Re: BusConnects Lucan to City Centre Core Bus Corridor Scheme
Lucan to Dublin City Centre

Here is the South Dublin County Council submission on the current Lucan to City Centre Core Bus Corridor SID Planning Application. Please acknowledge receipt of our submission by email.

Please note that on the attached GA drawing sheets there are notes (Yellow boxes) added and here is a summary of those notes in the Table below:

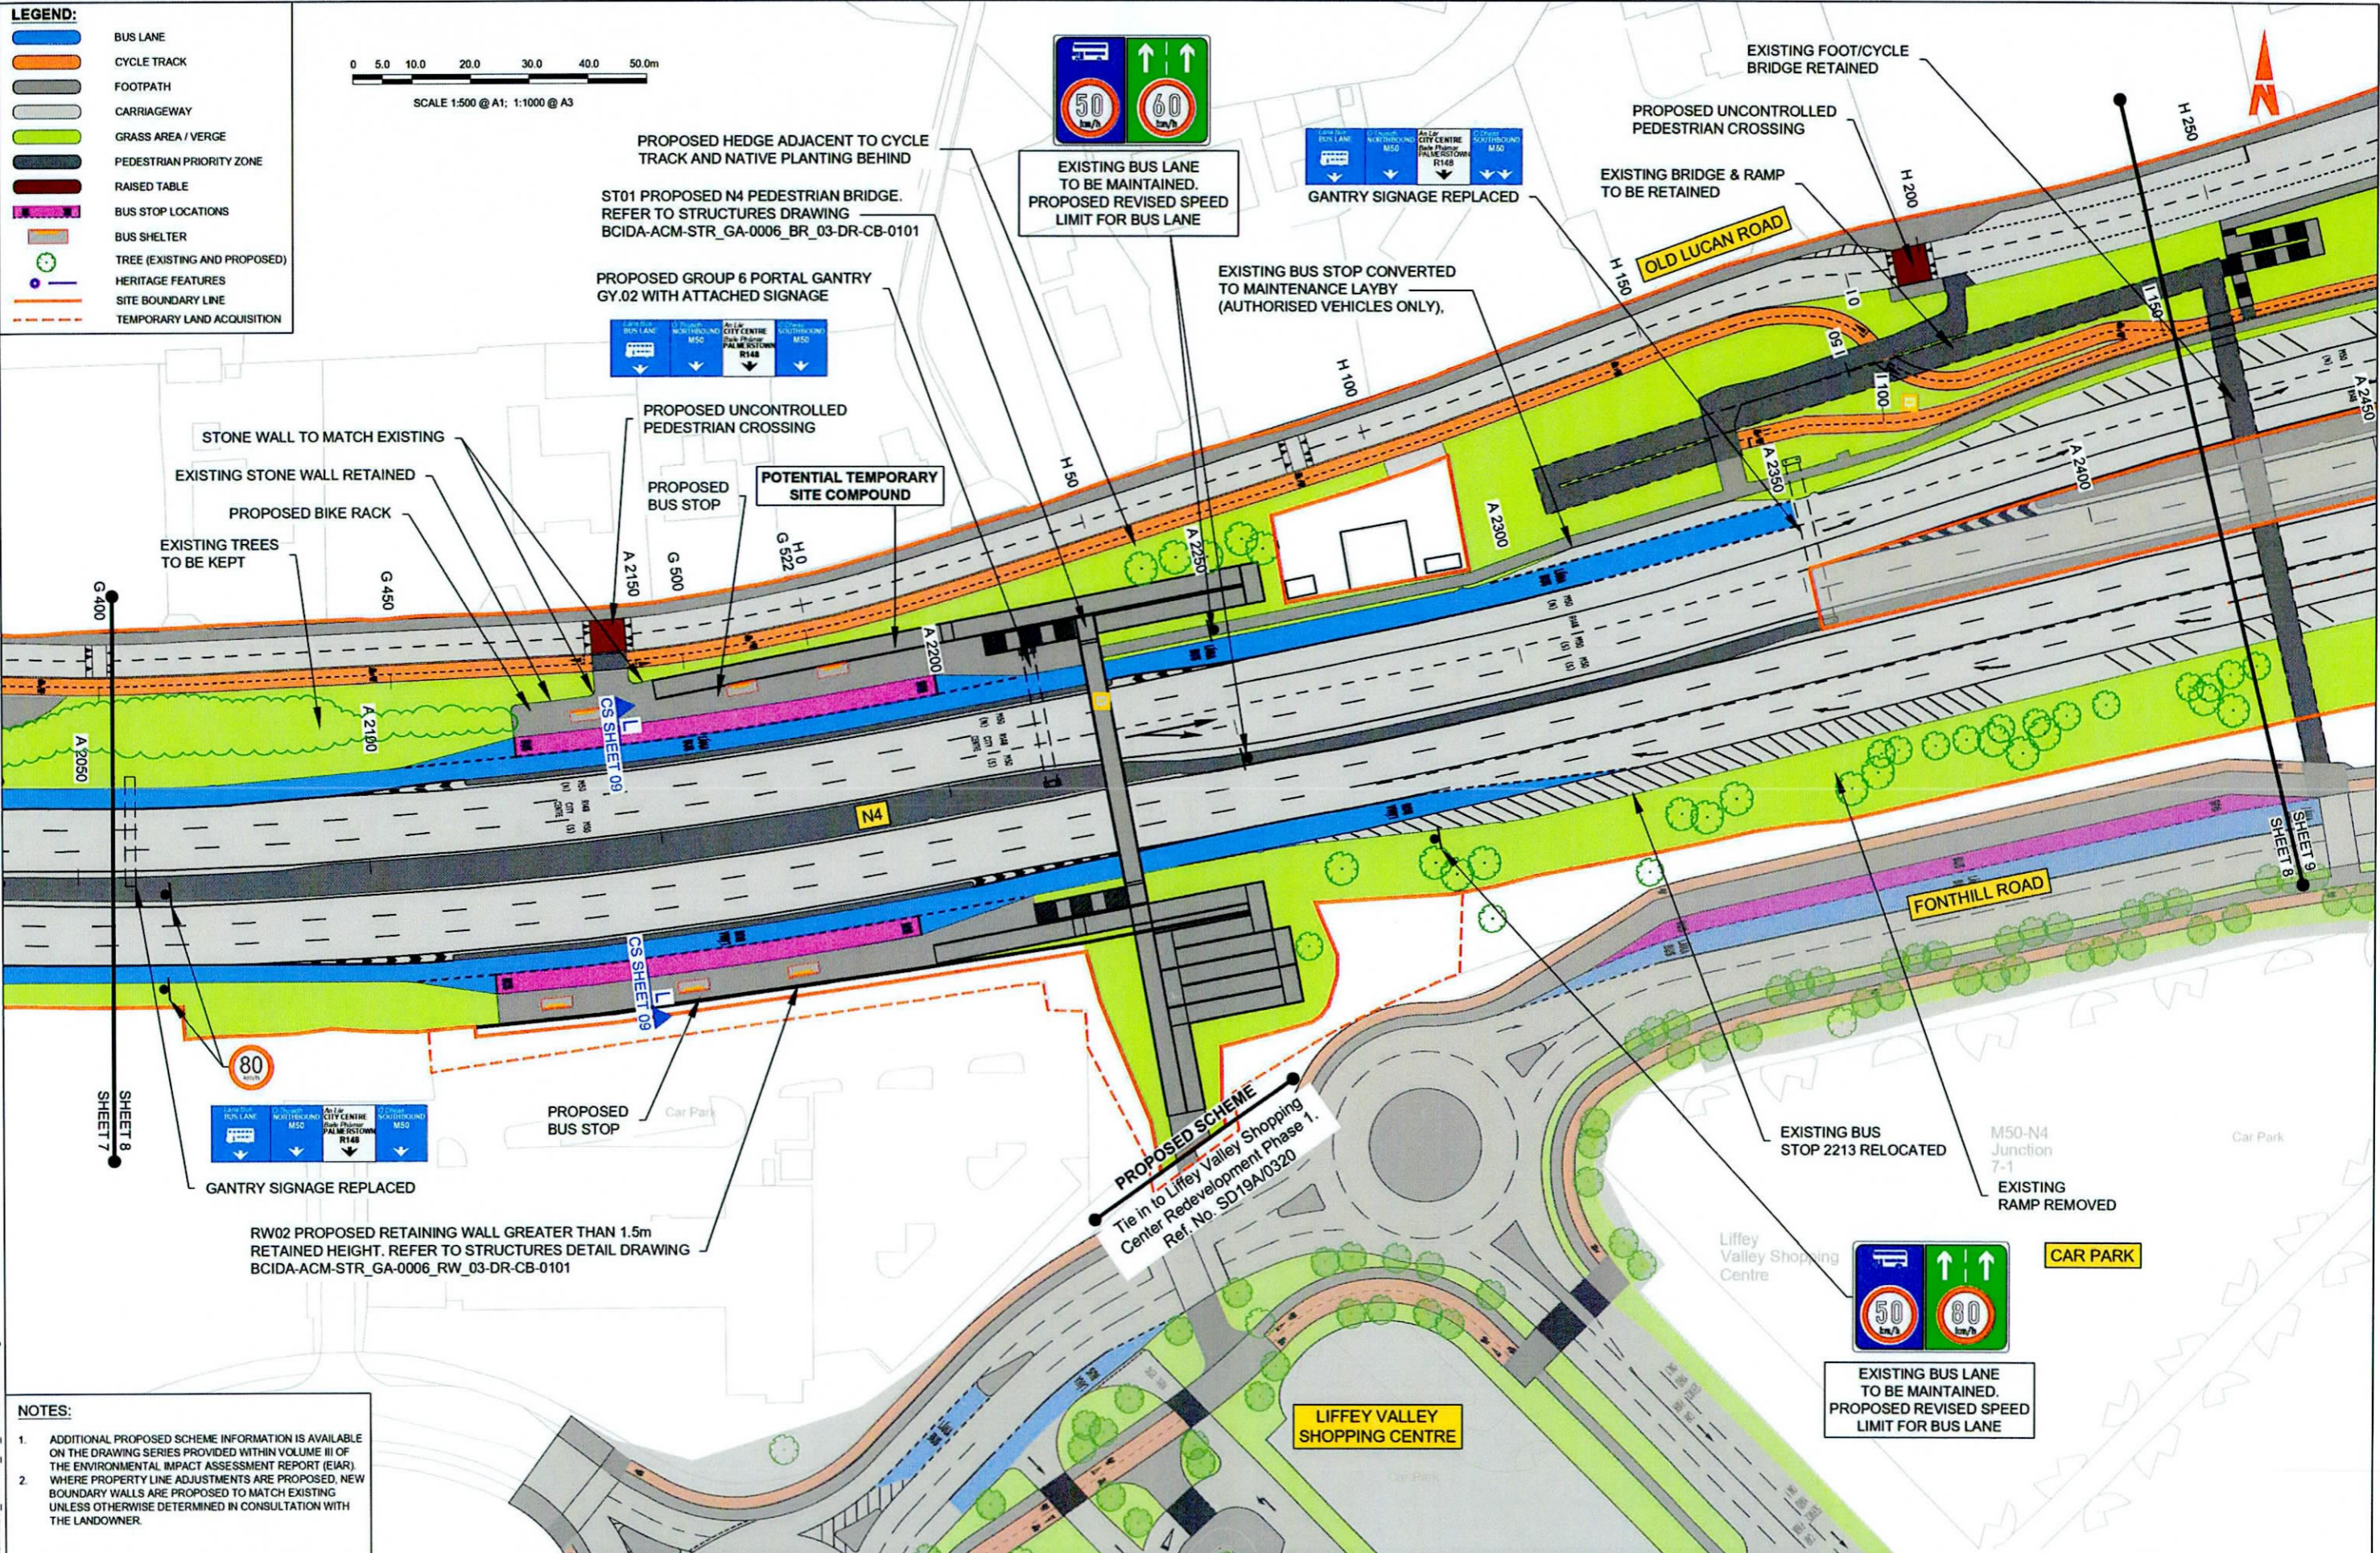
AT 31	Sheet 06	CH F 50	N4 Liffey Valley roundabout	Are these new or existing trees? Could the cycle track approach to the crossing be reconfigured to remove the 90 deg turn?
AT 32	Sheet 06	CH F 50	N4 Liffey Valley roundabout	Footpath could be reconfigured to reduce area of shared space.
AT 33	Sheet 07	CH G 300	Old Lucan Road at the Deadmans etc.	How will parking/set-down on footpath and cycle track be prevented (see street-view satellite)?
AT 34	Sheet 07	CH G 250	Old Lucan Road at the Deadmans etc.	Can entrance width be narrowed to align with existing pillars?
AT 35	Sheet 08	CH I 100	N4 at existing ped overbridge	Can a direct link between cycle tracks to be provided for cyclists using bridge and Old Lucan Road. Significant detour as shown
AT 36	Sheet 08	CH A 2200	N4 new over bridge	Are cyclists permitted on this bridge? Is 3.0m wide enough if so?
AT 37	Sheet 09	CH I 350	Existing cycle track to cross M50	Does cycle track narrow along this section? Should existing be widened?

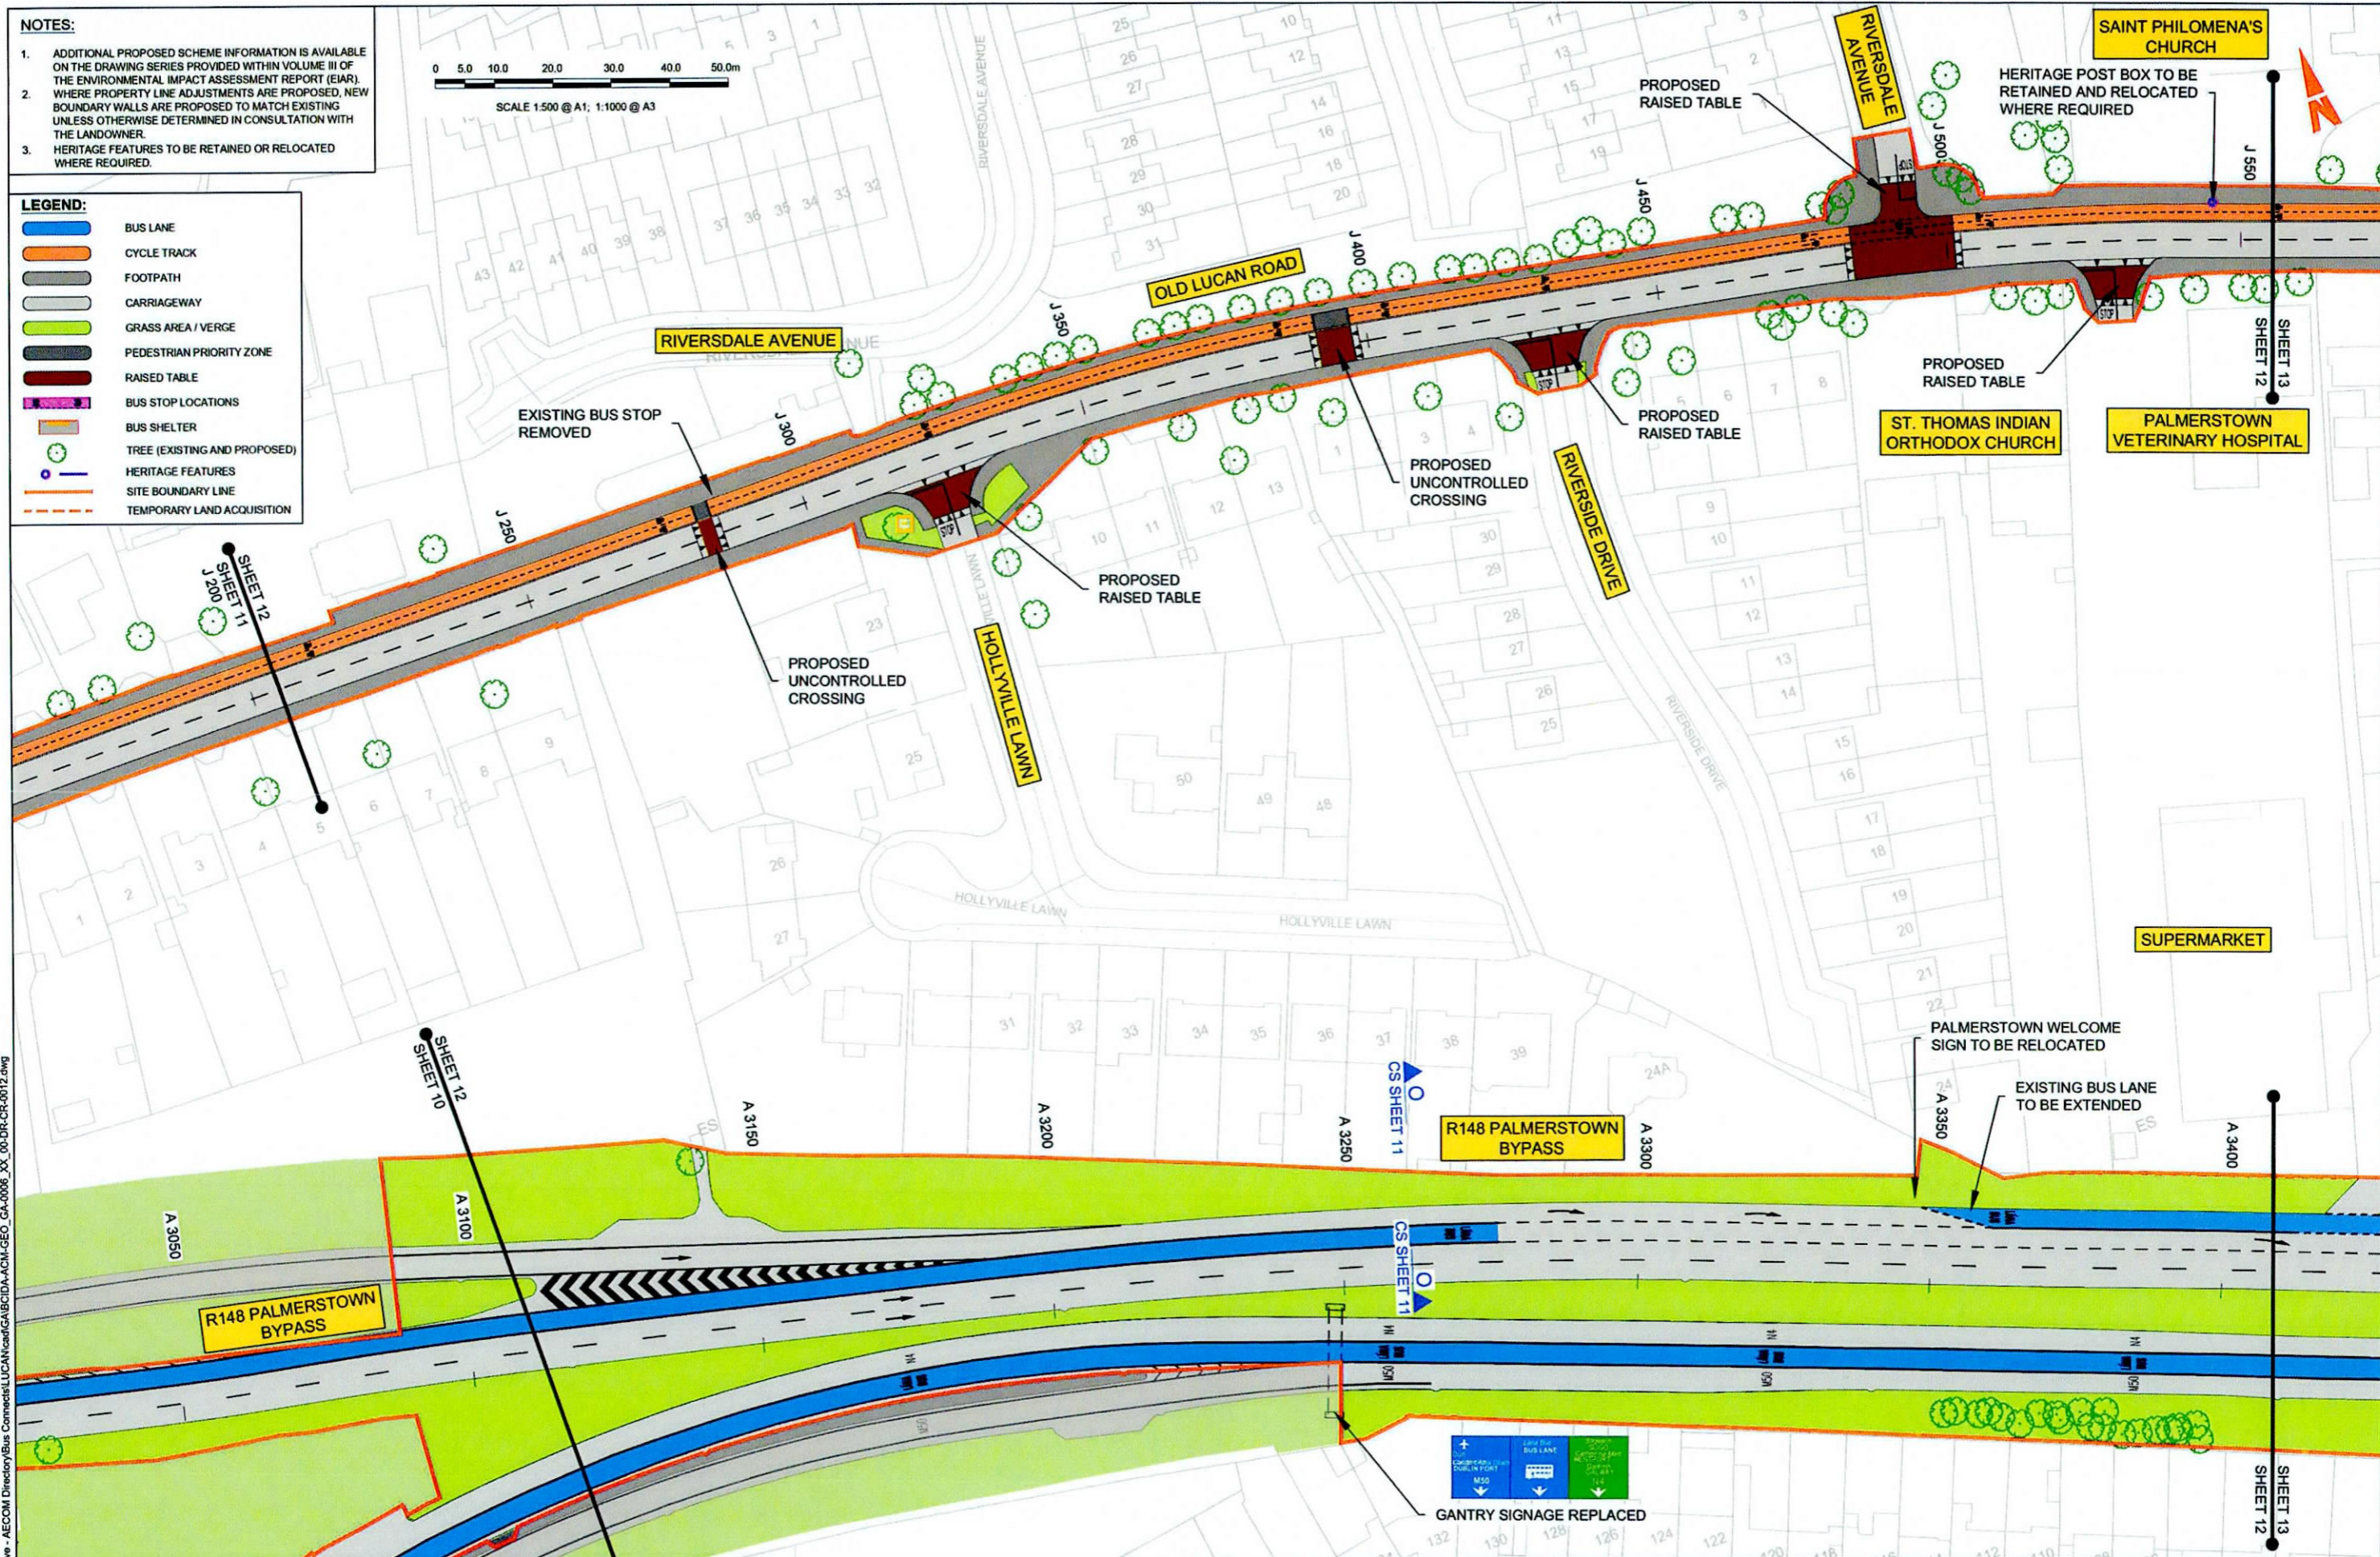
AT 38	Sheet 11	CH I 750	Existing cycle track to cross M50	Is cycle track wide enough?
AT 39	Sheet 12	CH J 300	Old Lucan Road and Hollyville Lawn	Can radius be tightened? If stop line is at road edge, who has priority?
AT 40	Sheet 13	CH J 600	Old Lucan Road	Cycle track white line should break at crossing.
AT 41	Sheet 14	CH K 0	Junction of Old Lucan Road and Kennelsfort Road Lwr	See previous note re: left to go right
AT 42	Sheet 14	CH K 150	Junction of Old Lucan Road and Mill Lane	Significant sweep from kerb end to entrance.
AT 43	Sheet 15	CH K 275	Old Lucan Road to The Oval	If this footpath is to serve as a shared path to link The Oval to the two way, it needs to be significantly wider. Could the western footpath be removed and the traffic lanes shifted west? Or the path widened into the green area.
